FLORIDA POWER & LIGHT COMPANY
ST. LUCIE PLANT UNIT 2

CONTAINMENT ISOLATION
VALVE TESTING
SHEET 6
FIGURE 6.2-74

CONTAINMENT ISOLATION
VALVE TESTING
FIGURE 6.2-69

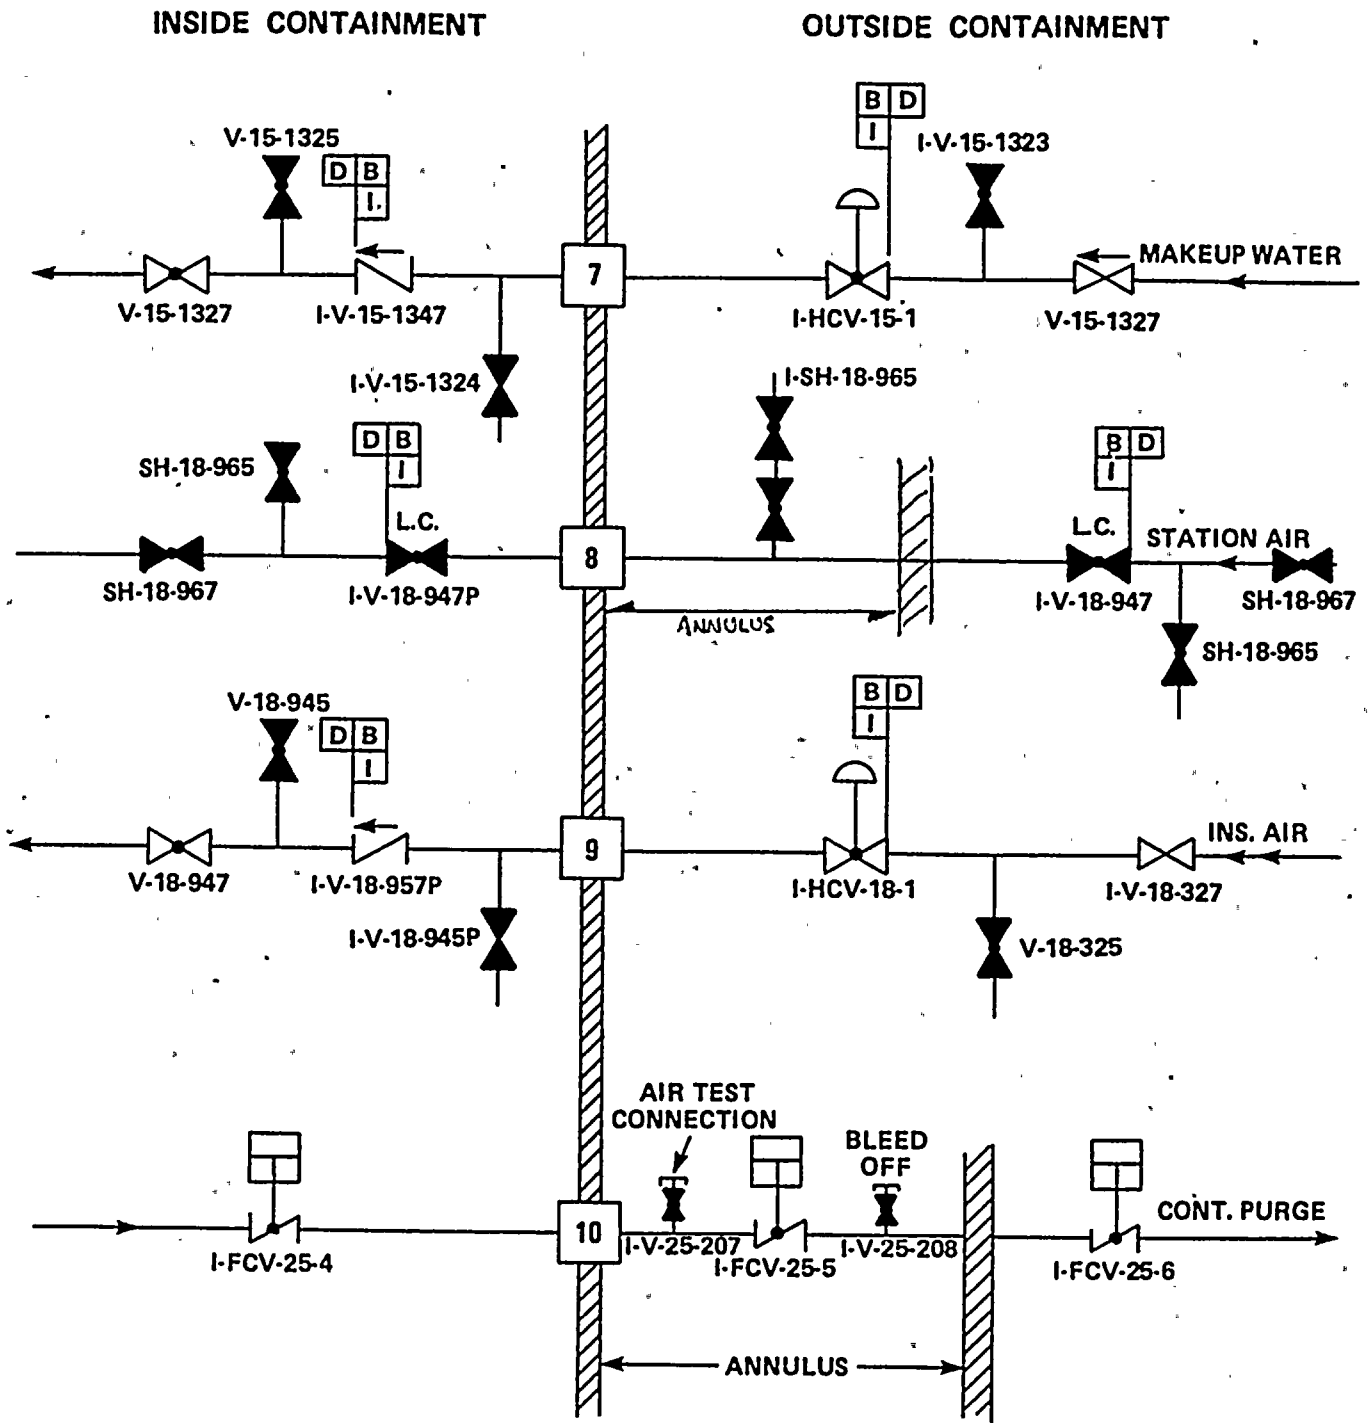
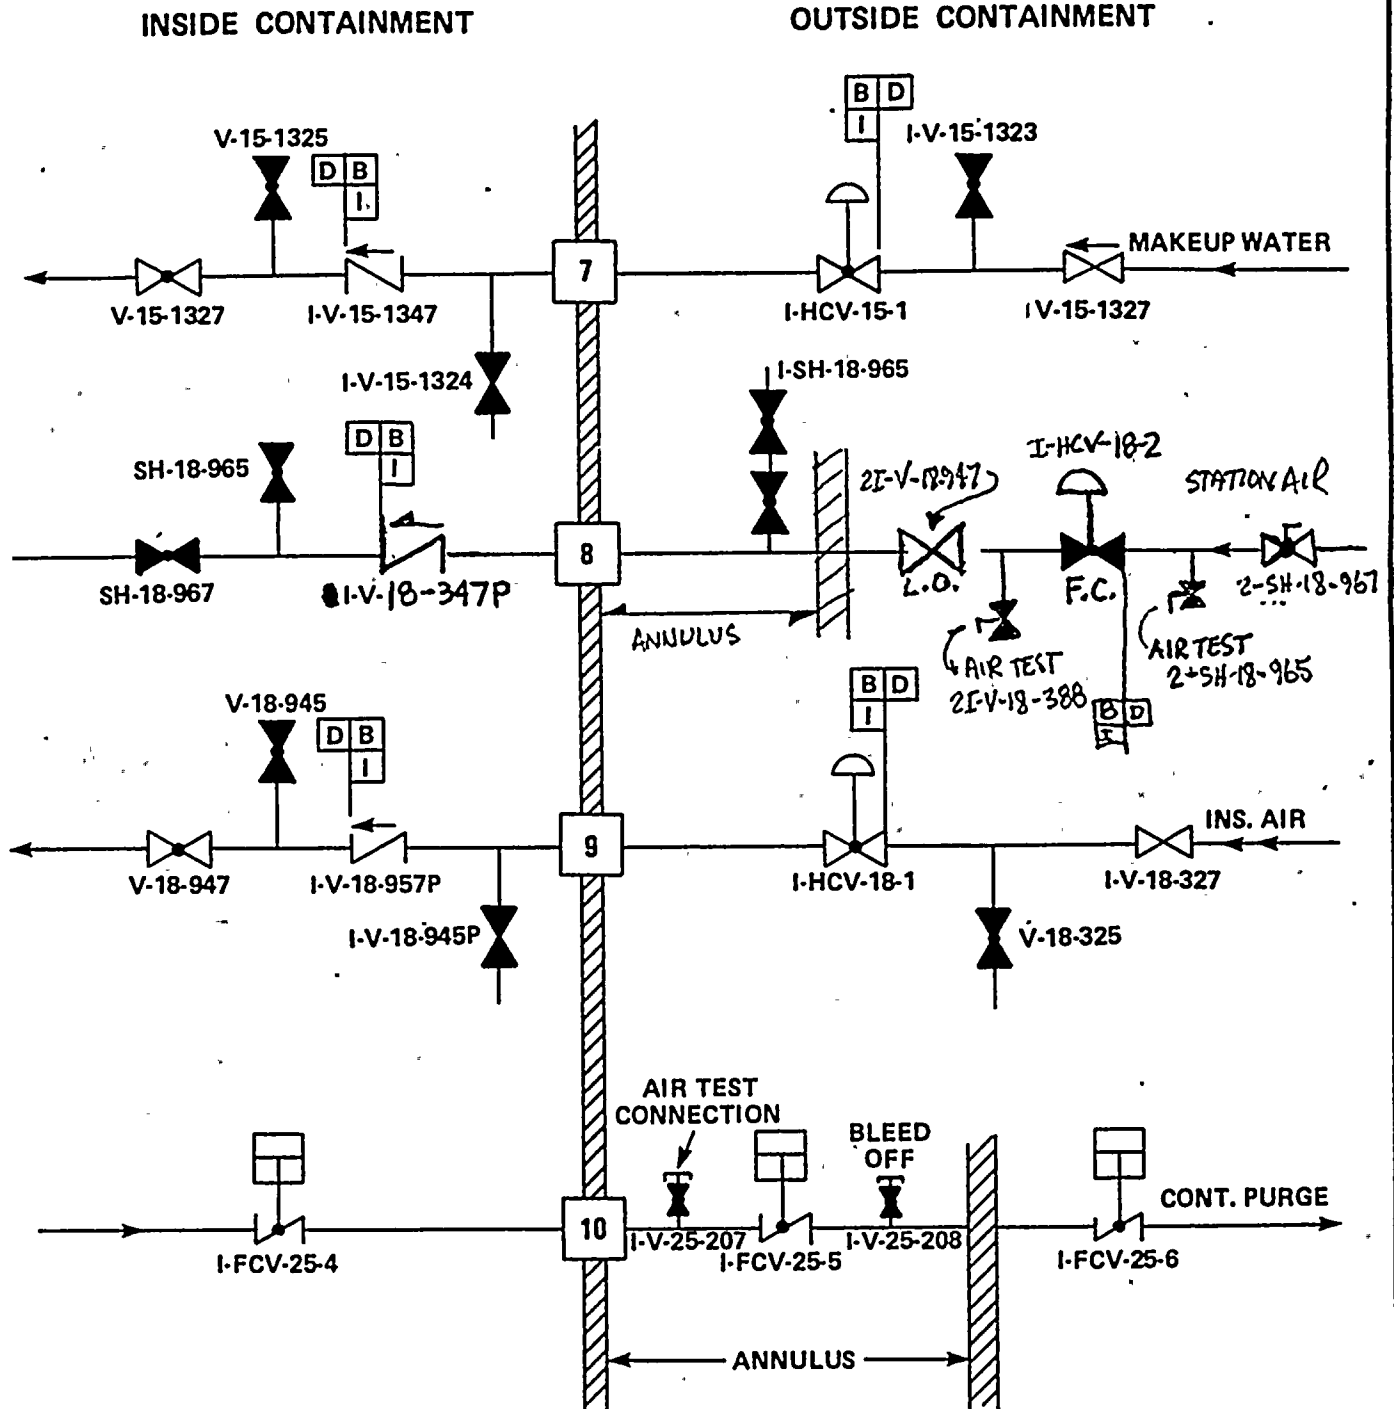
BEFORE PCIM 300-283
(NOTE "ERROR")

AFTER PC/M 300-285

NOTE: UNIT 2 VALVES
 NORMALLY PREFIXED WITH "2" IE,
 2V-XXXXX etc.
